**DAC 25/07/23 – 21 PARNELL PLACE NEWCASTLE EAST –
DA2022/00705 – MIXED USE - ALTERATIONS AND ADDITIONS TO
EXISTING HOTEL OR MOTEL ACCOMMODATION (NEWCASTLE
BEACH HOTEL), ANCILLARY FOOD AND DRINK PREMISES AND
COMMERCIAL USE (ANCILLARY HOTEL SPA) AND DUAL
OCCUPANCY (ATTACHED 2 X DWELLINGS)**

PARNELL PLACE

21 Parnell Place, Newcastle East, NSW 2300
LOT 1 /DP815595

GROUND FLOOR PLAN
SCALE 1:100

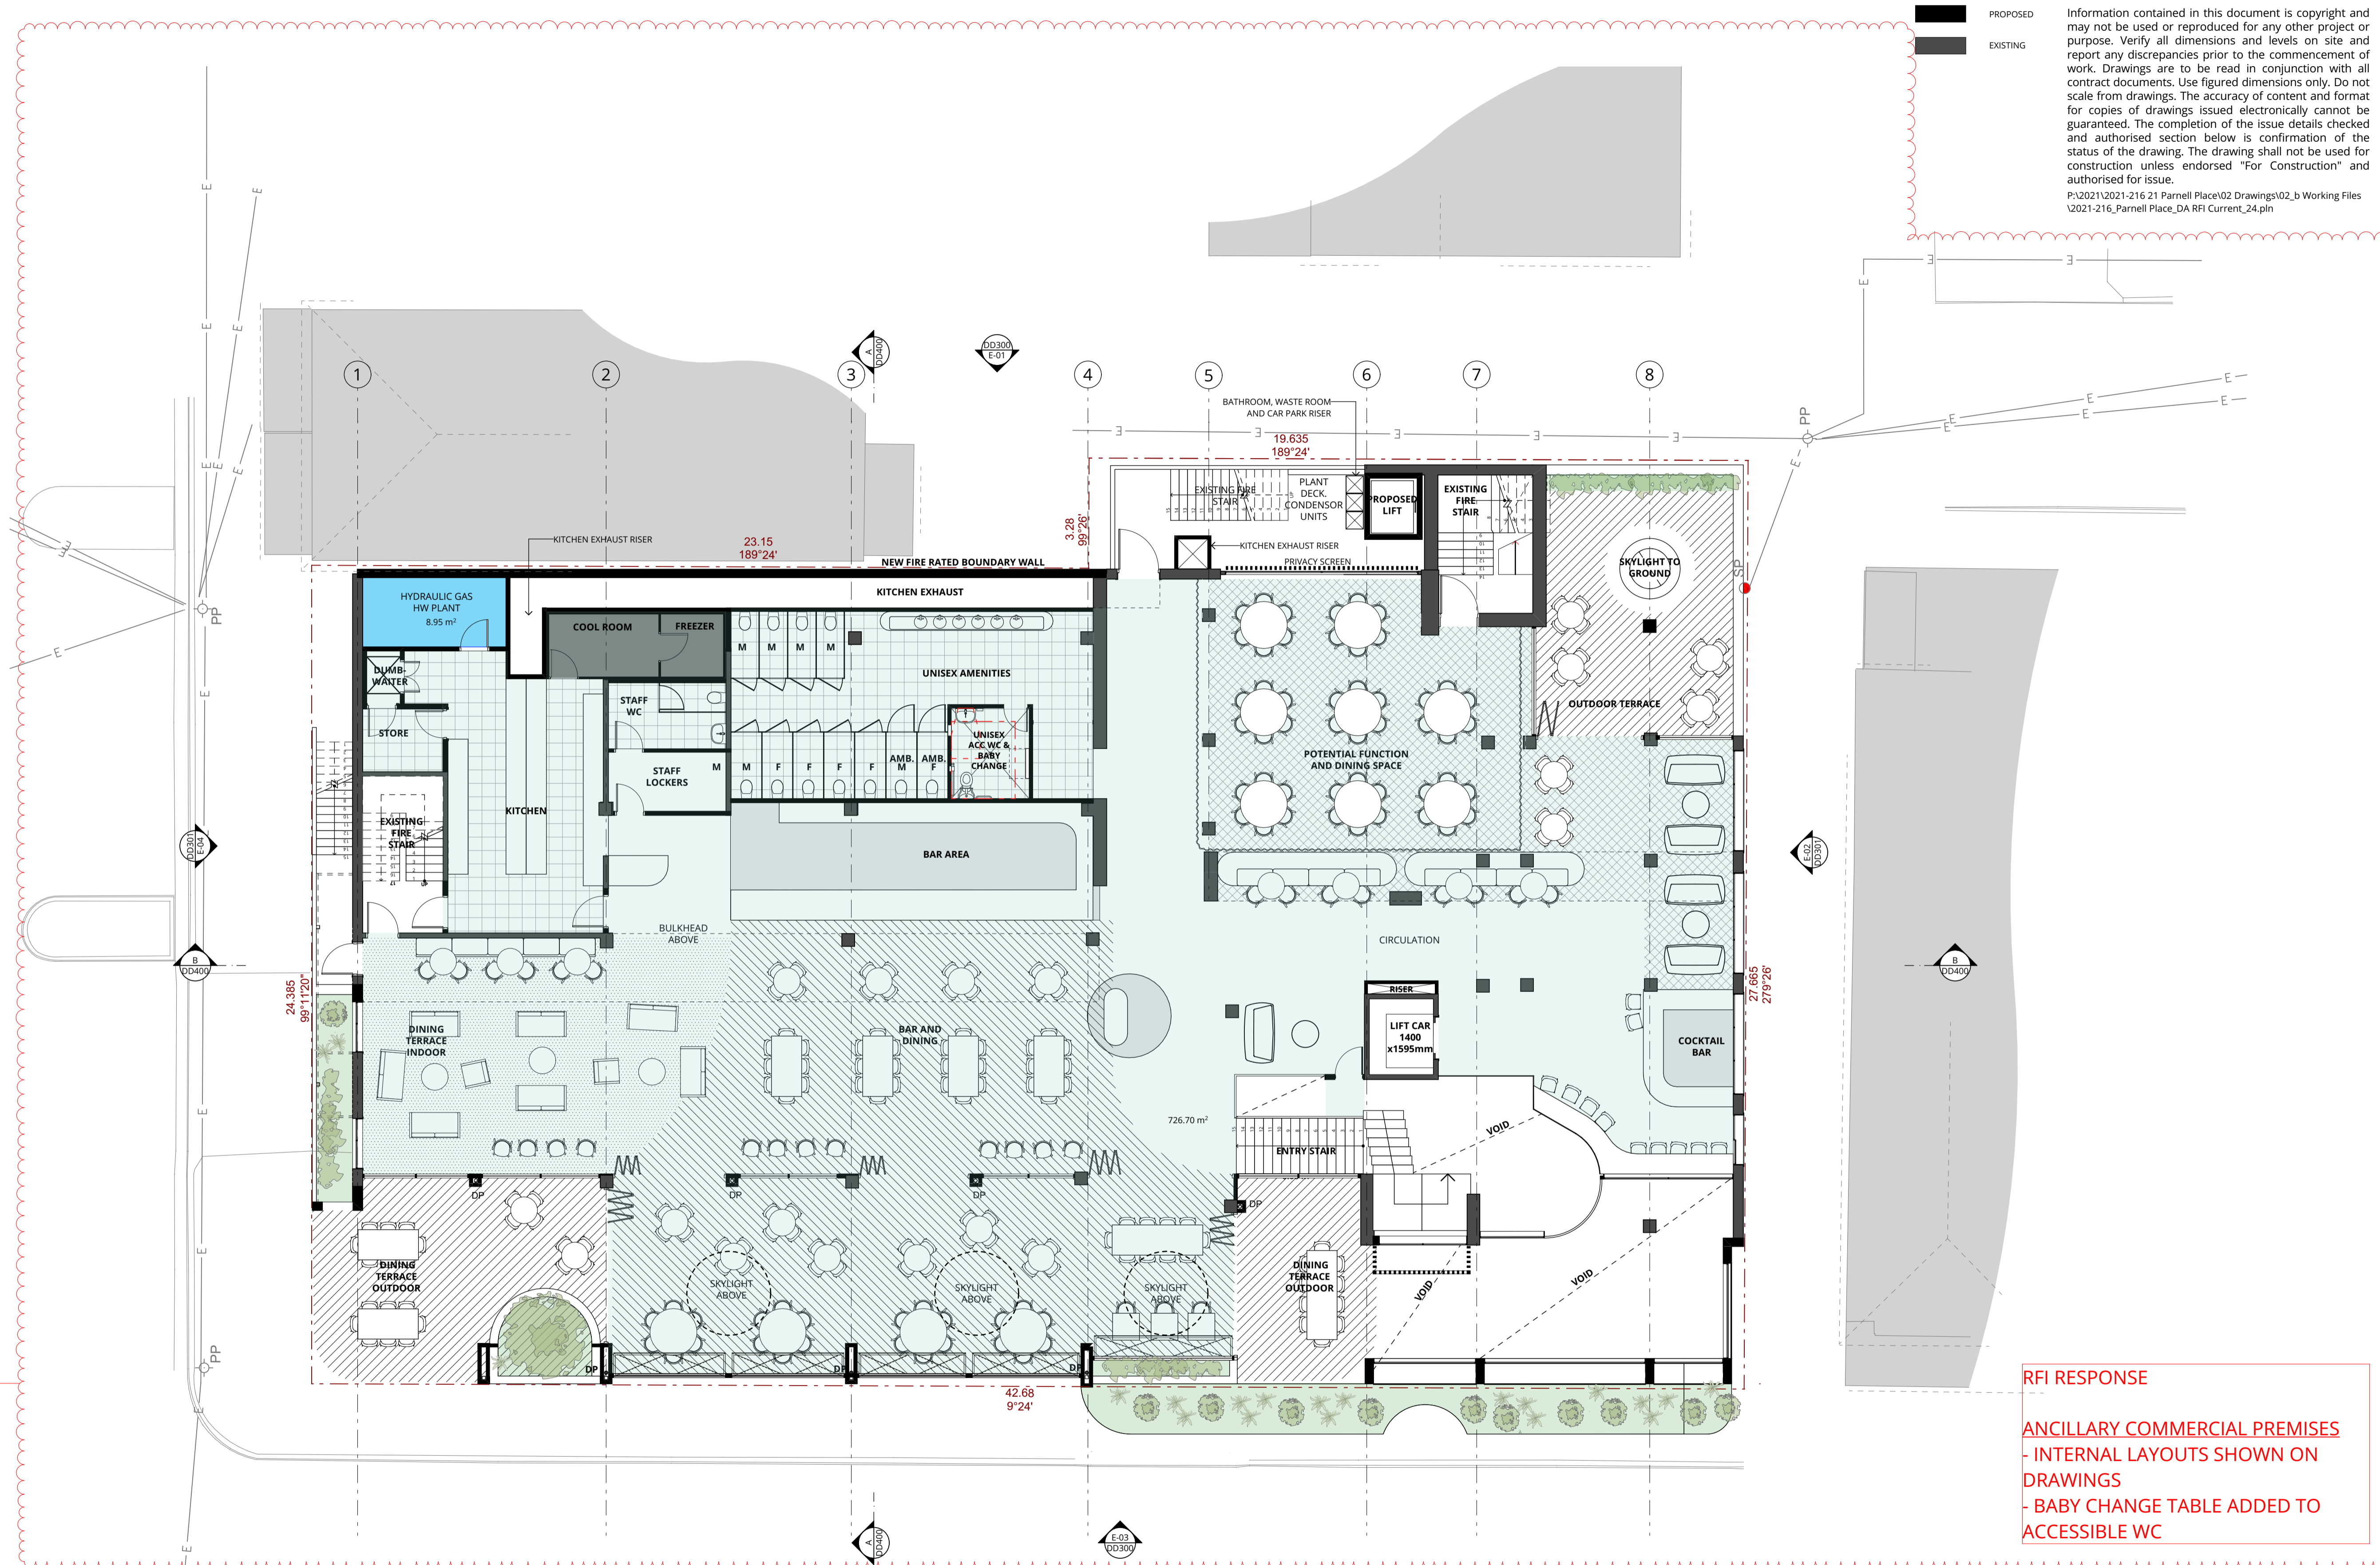
WASTE SERVICES
- BIN AND KEG ROOMS REWORKED TO PROVIDE SPACE FOR MORE BINS, ACCESS DOORS ADJUSTED TO SUIT
- 2x 240L GREEN BINS ADDED TO RESIDENTIAL WASTE ROOM

ANCILLARY COMMERCIAL PREMISES
- INTERNAL LAYOUTS SHOWN ON DRAWINGS
- BABY CHANGE TABLE ADDED TO ACCESSIBLE WC

1. FIRST FLOOR PLAN
SCALE 1:100

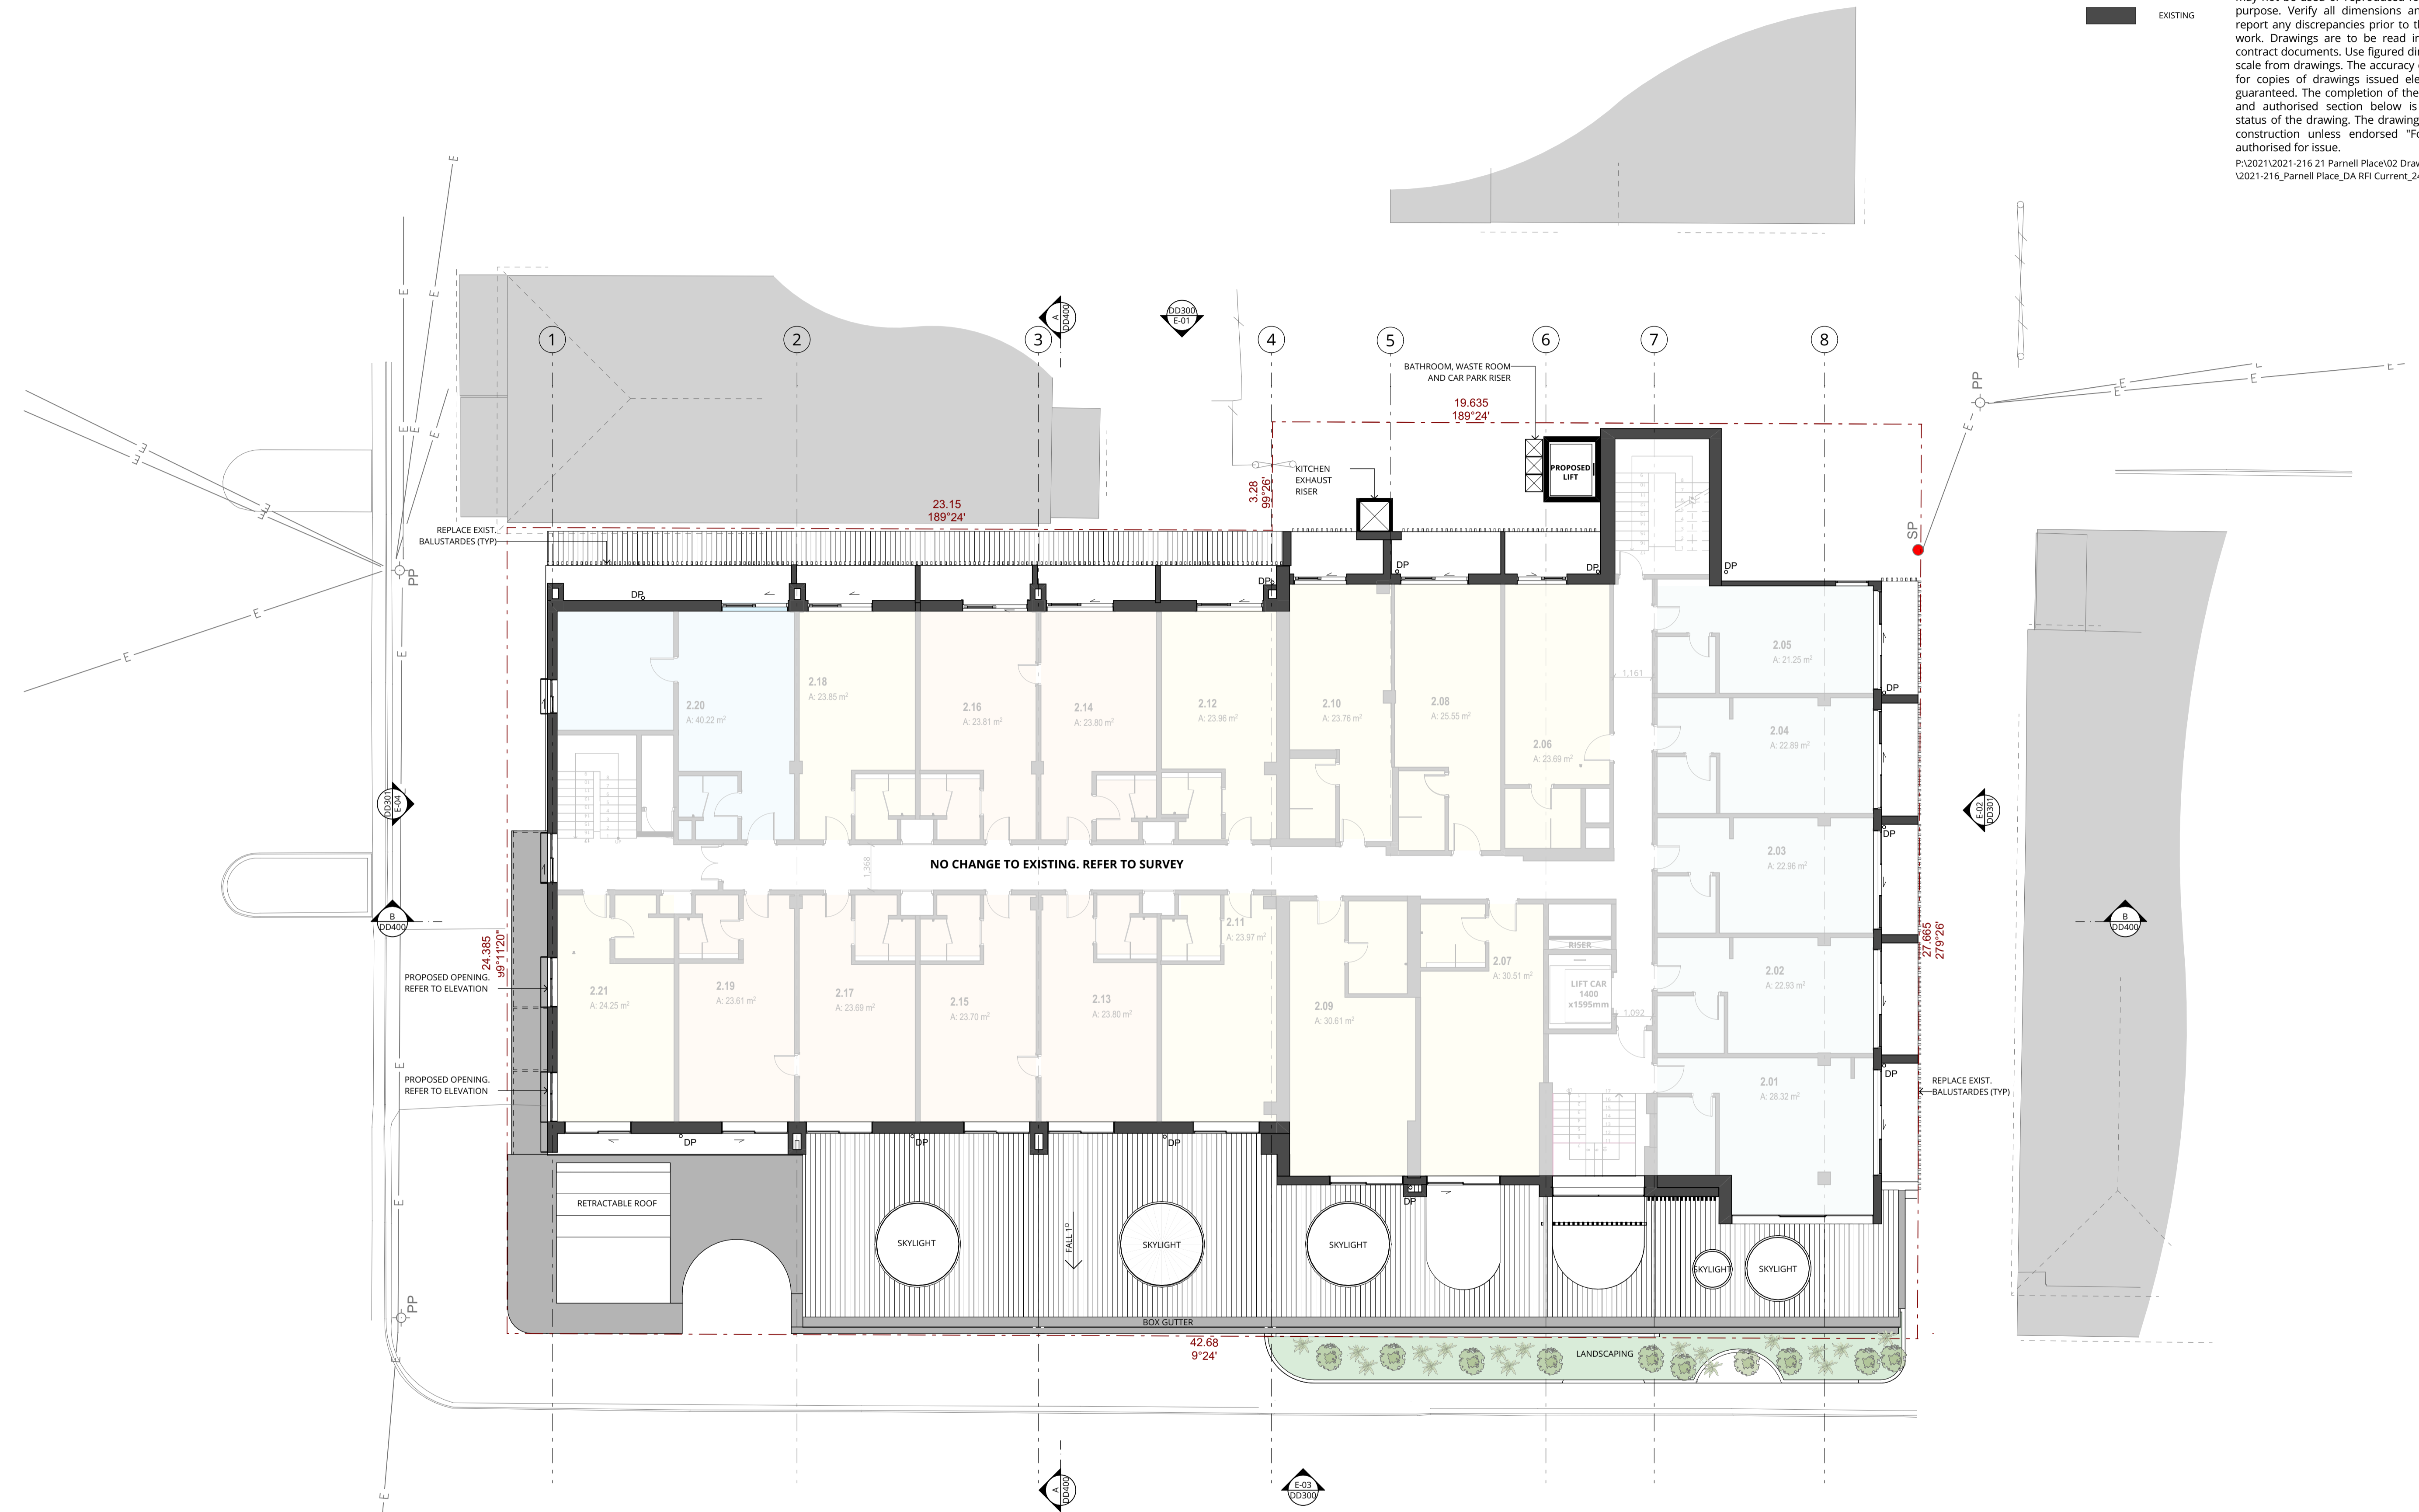
- INTERNAL LAYOUTS SHOWN ON DRAWINGS
- BABY CHANGE TABLE ADDED TO ACCESSIBLE WC

4. FOURTH FLOOR PLAN
SCALE 1:100

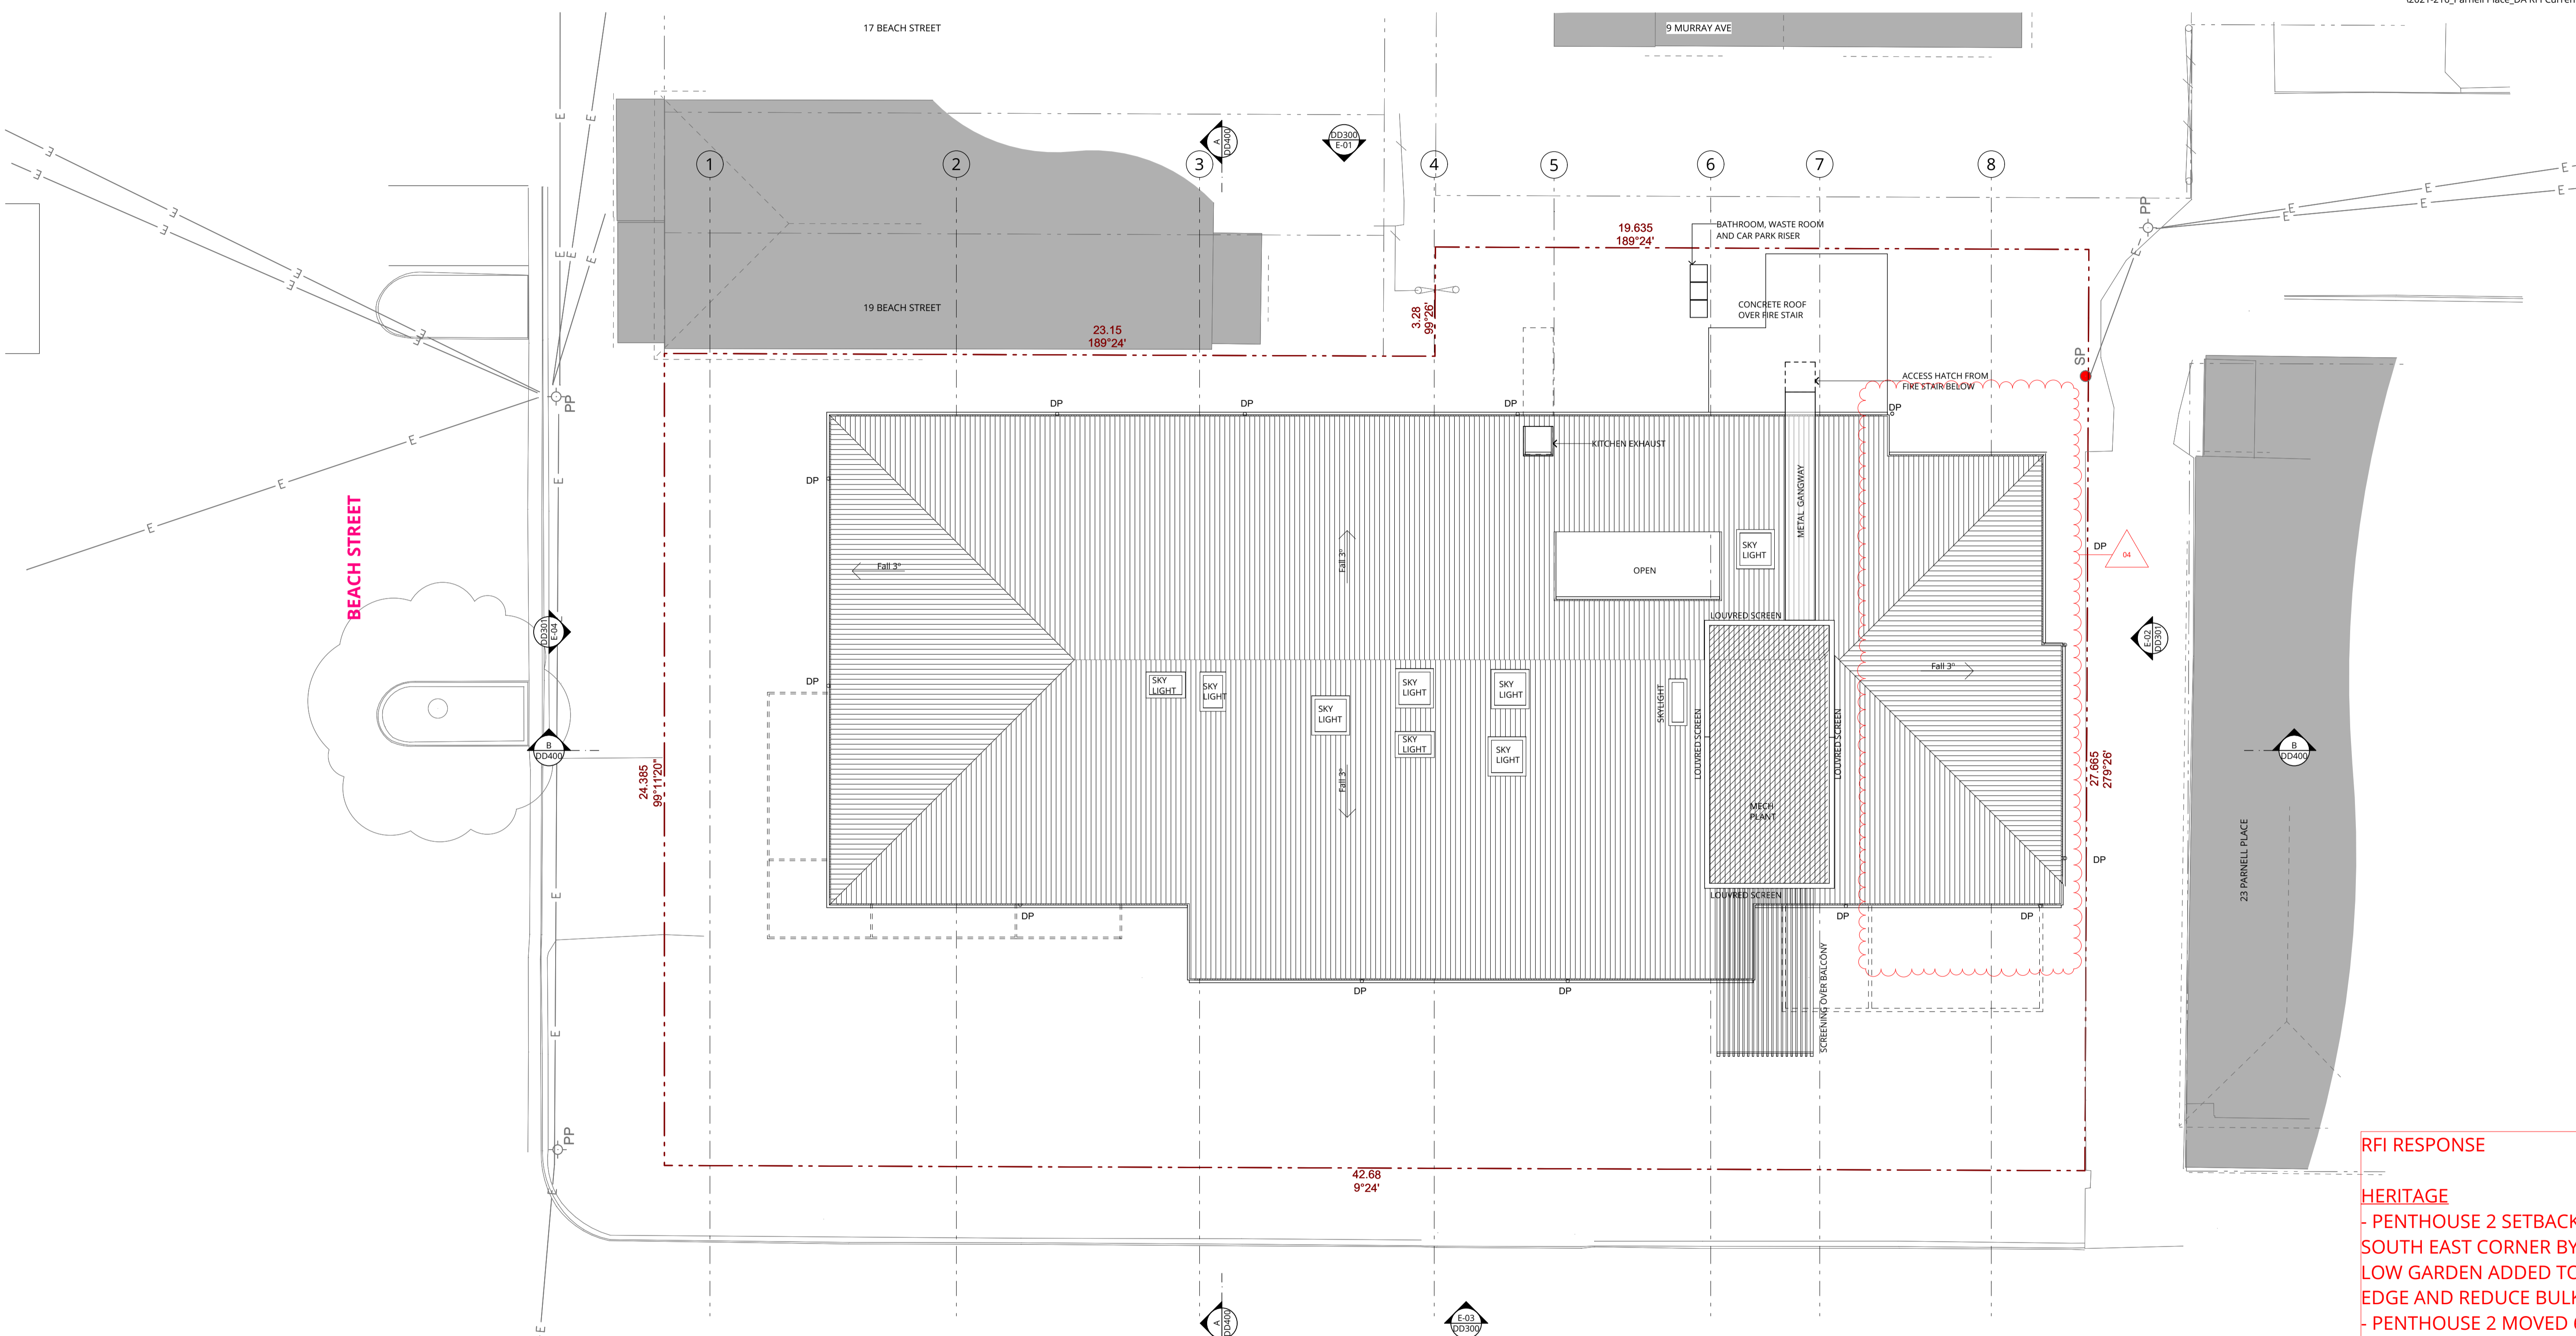
- PENTHOUSE 2 SETBACK FROM SOUTH EAST CORNER BY 1200MM AND LOW GARDEN ADDED TO SOFTEN EDGE AND REDUCE BULK & SCALE
- PENTHOUSE 2 MOVED 600MM TO WEST TO MAINTAIN FLOOR AREA
- PENTHOUSE 2 EAVE REDUCED BY 600MM TO REDUCE SCALE
- ADDITIONAL LANDSCAPING TO PENTHOUSE 01 NORTH-WEST CORNER
